# Rezoning Transportation Analysis

Petition Number: 2021-174

Date	Description
11-22-21	First Review (TM)

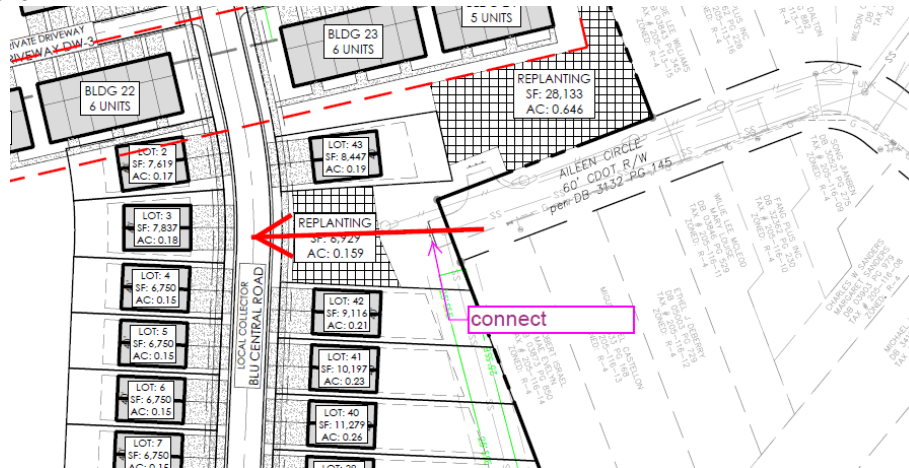
- Curblines:** The proposed zoning district has a setback measured from back of the existing or proposed future curblines.
  - East Westinghouse Boulevard:** Location of the future back of curb and gutter will be relocated is 33 feet from the existing street centerline. Revise site plan to show the future back of curb.

Label and dimension the existing and future curb and gutter from the centerline for each road on the site plan.
